14 October 2020

**East Anglia TWO (EA2) and East Anglia ONE North (EA1N): dDCO Requirement 34  
East Anglia THREE (EA3): DCO Requirement 33  
Air Defence Radar Mitigation**

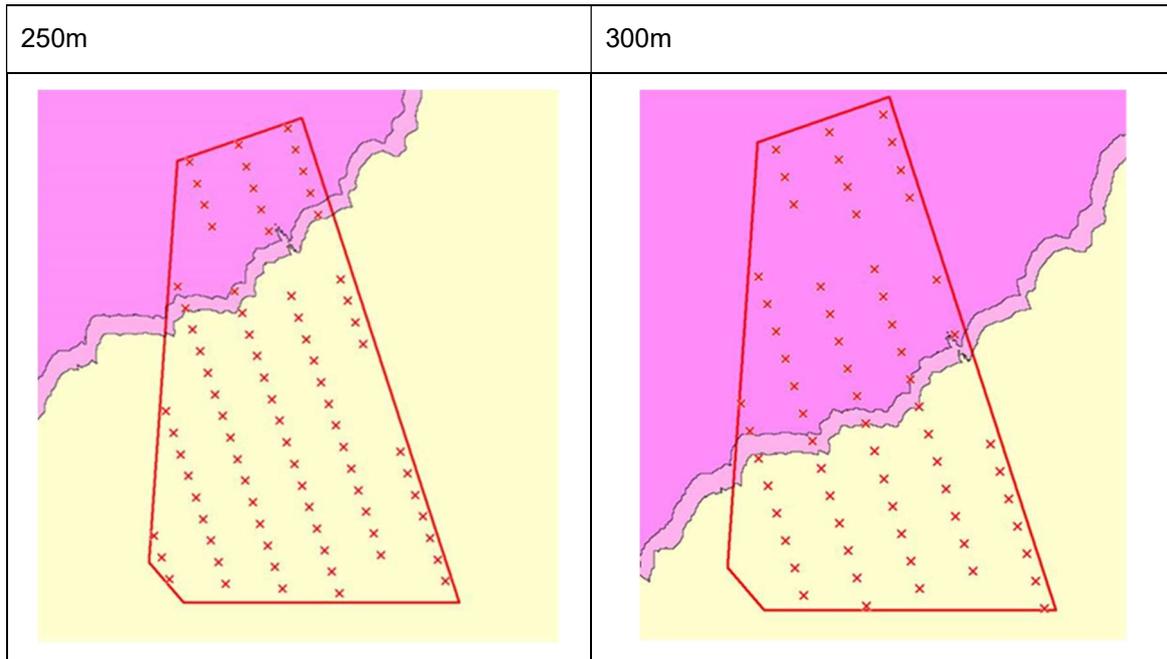
During our call on 15 April, Jon, you indicated that SPR has used incorrect antenna aperture height in its radar modelling of RRH Trimmingham. You suggested that with the correct antenna aperture height, all the EA2 would be in RLOS of Trimmingham at 250m. We were surprised that the difference in aperture height would have such a significant impact on RLOS. To this end, we asked Cyrrus to re-do the EA2 modelling at 250m and 300m at the correct aperture height, comparing it with the results in the radar modelling. The results are shown below:

As you will observe, the difference is not significant. I would also draw your attention to East Anglia THREE's non material change (EA3 NMC) which DIO is currently considering. The incorrect Trimmingham aperture height had also been used in EA3, and not picked up by the MOD. We have now rectified this in the EA3 NMC documentation and again the difference is not significant.
